**SECTION 00 90 03
BIDDING AND CONTRACT REQUIREMENTS
ADDENDUM NUMBER 3**

Re: ADDENDUM NUMBER (3) TO THE BIDDING DOCUMENTS FOR

**McHenry County College
University Center at MCC**
Architect's Project Number: 22-050

SHEET NUMBER:
AD1.10

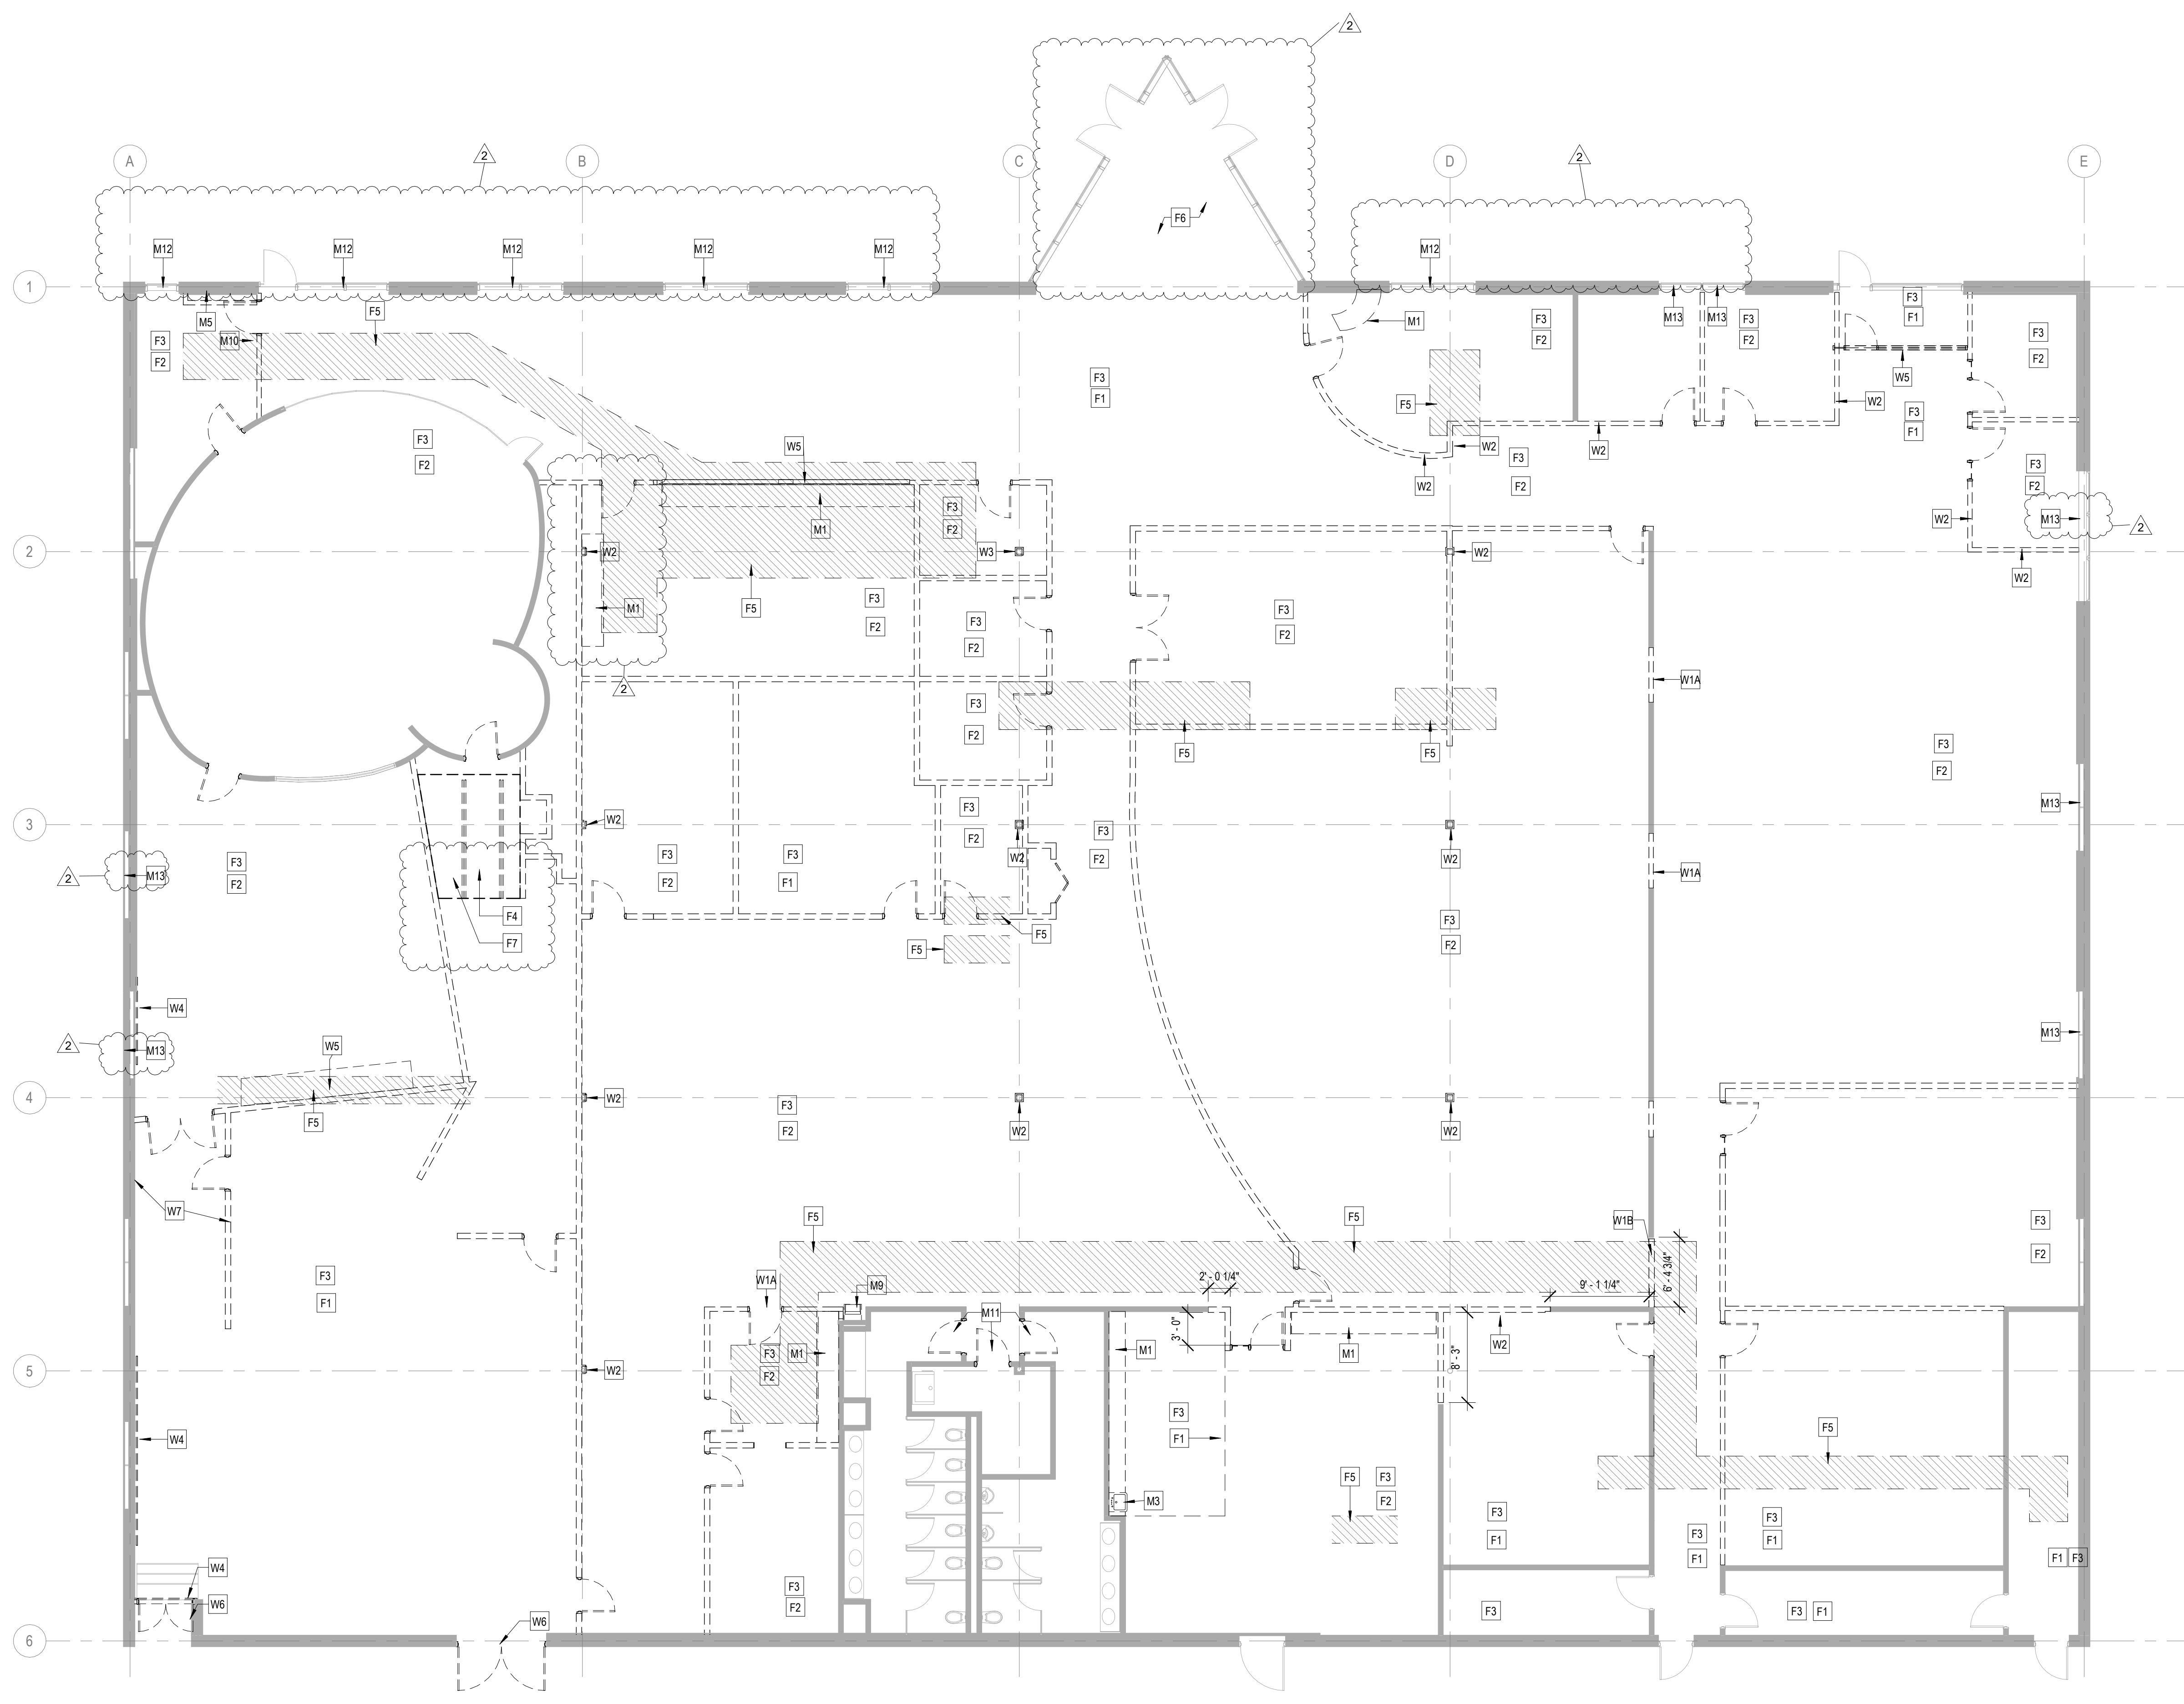
2. AD1.10
 - A. **REVISE** scope notes for salvage requirements as indicated.
 - B. **REVISE** scope notes for removal of misc. items and FF&E as indicated.

- C. **ADD** note M1 for additional millwork to be removed as indicated.
 - D. **ADD** note M13 for removal of blinds from windows indicated.
 - E. **ADD** note M12 for removal of existing window film complete as indicated.

- F. **ADD** note W7 for removal of metal panel wall system as indicated.
 - G. **ADD** note F7 for removal of metal plate flooring as indicated.
3. AD2.10

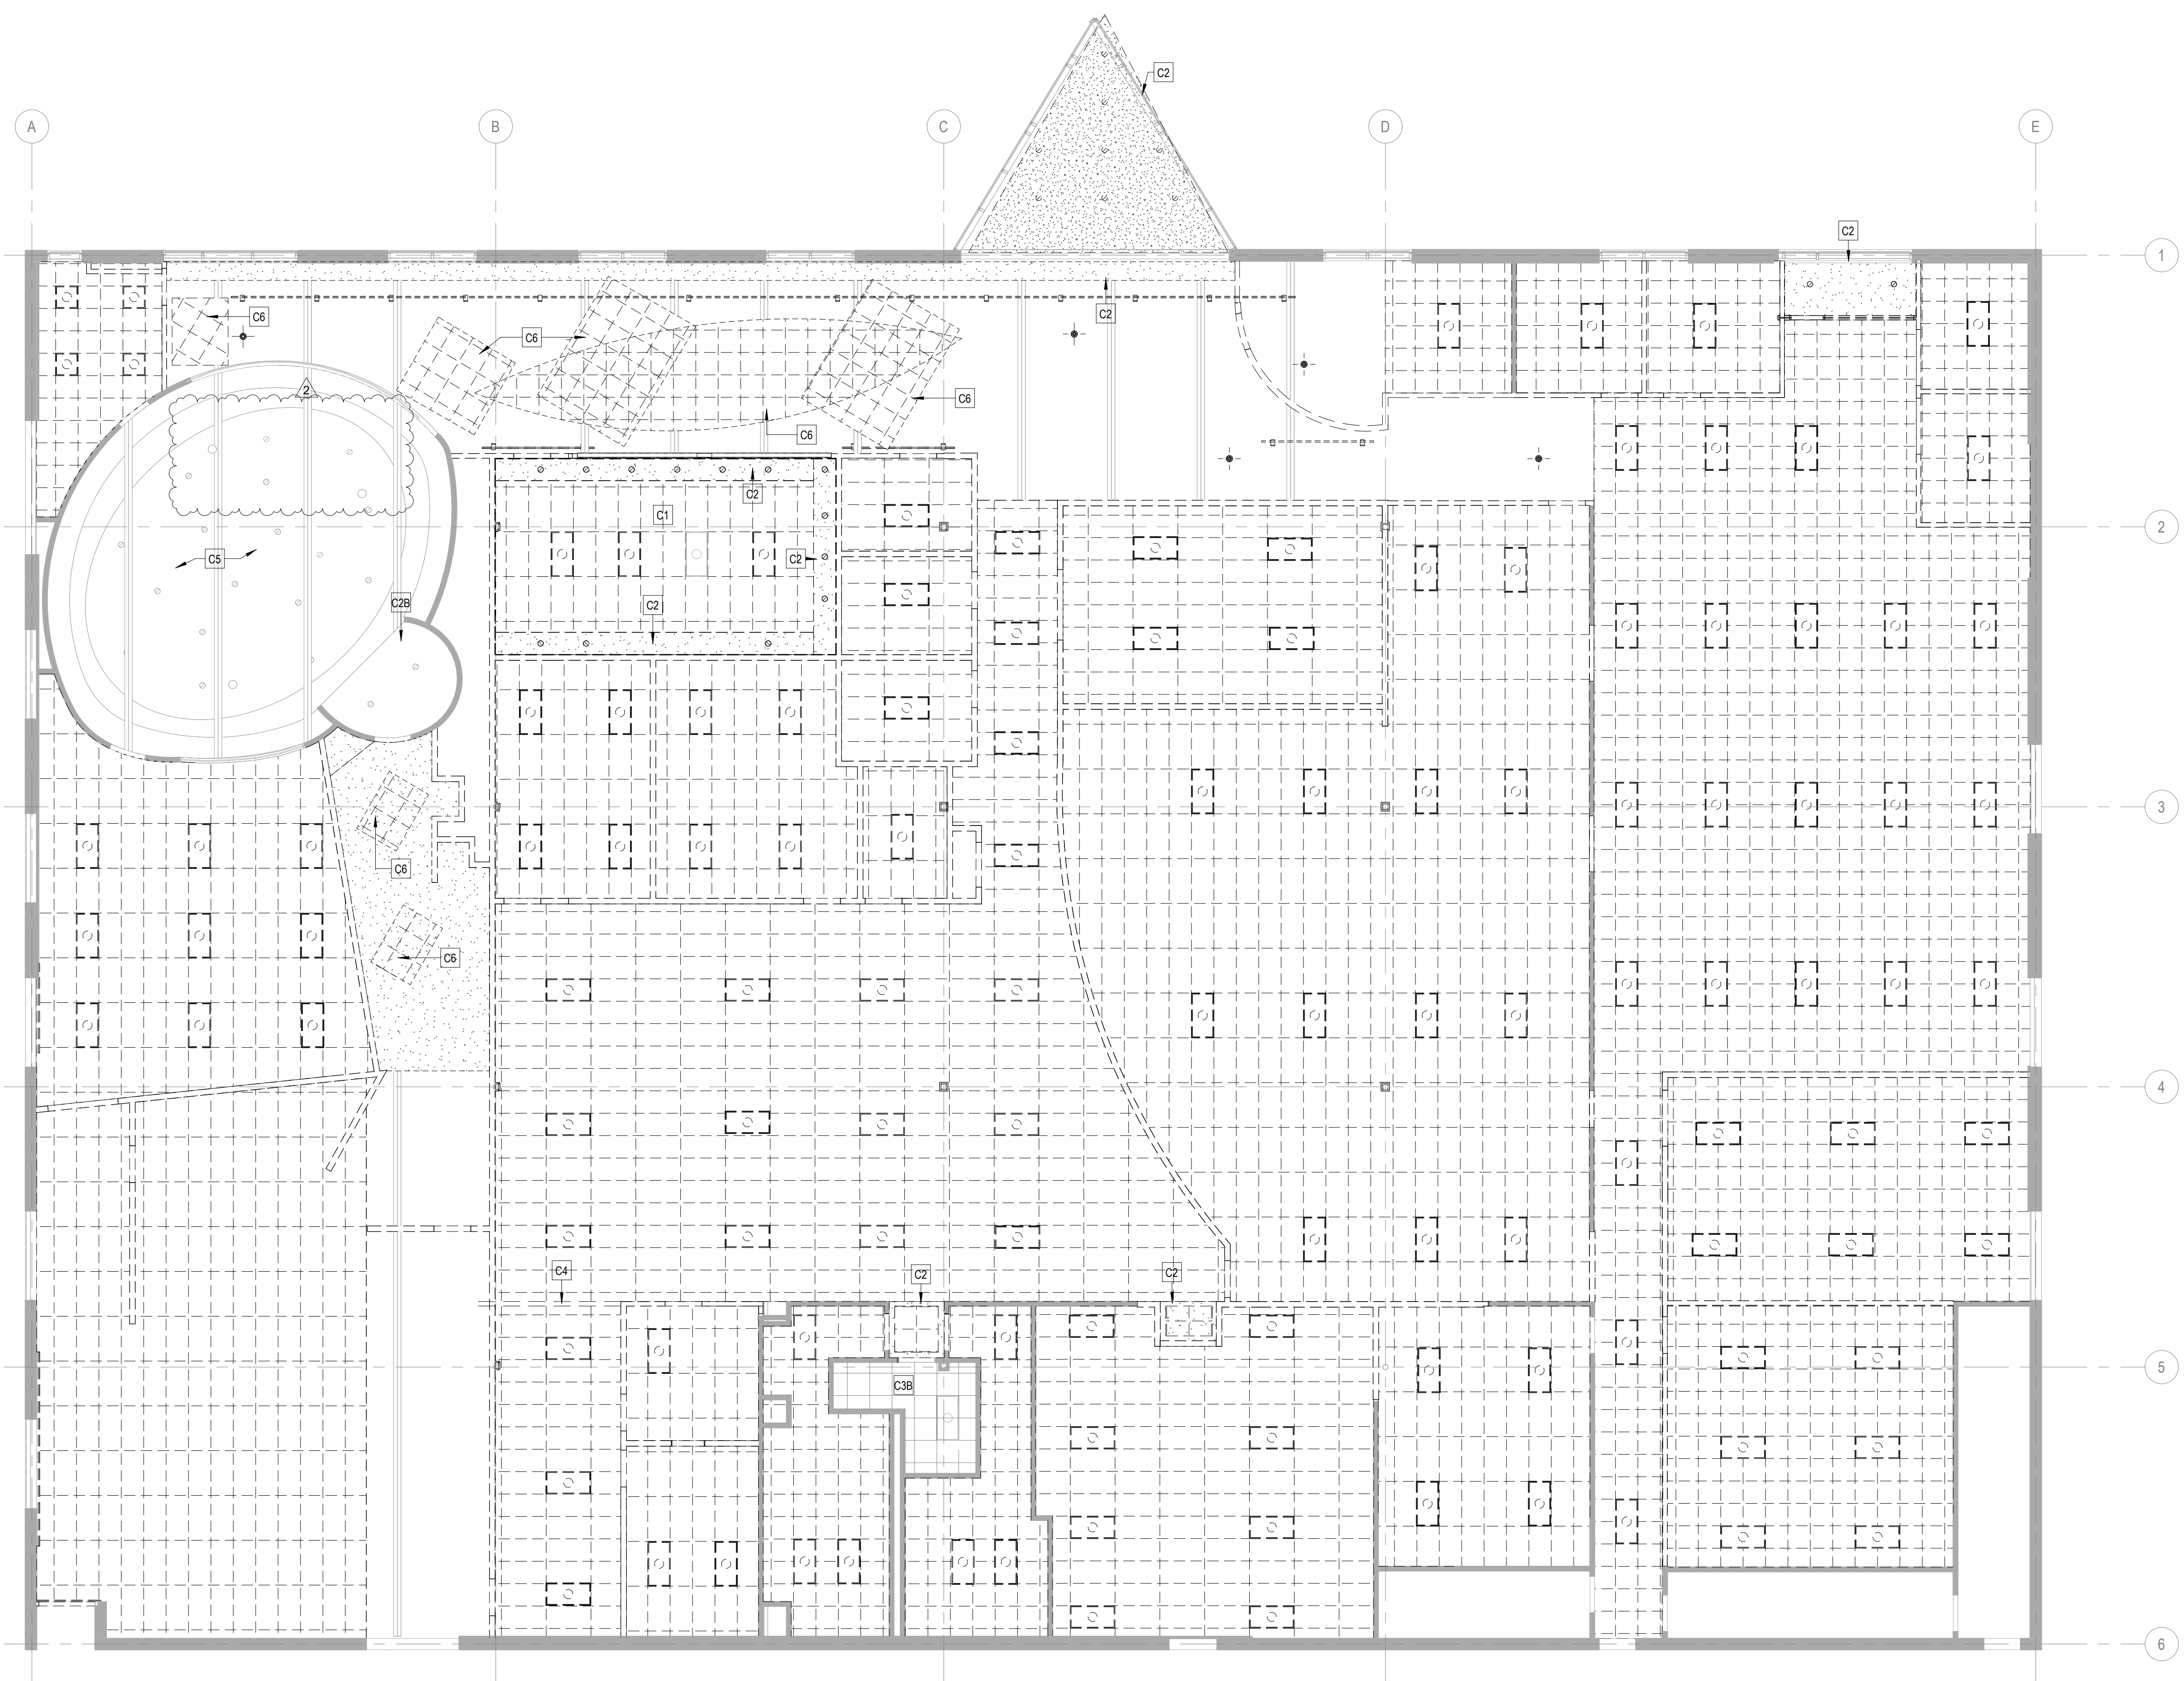
- A. **REVISE** scope notes for salvage requirements as indicated.
 - B. **REVISE** scope notes for removal of misc. items and FF&E as indicated.
 - C. **DELETE** note 7. Contractor to complete work required for new mechanical layout in circular classroom without modification to existing curved ceiling.

- D. **REVISE** note S3A and SAT ceiling demo symbol description as indicated to include complete removal of batt insulation on top of all SAT ceiling systems.
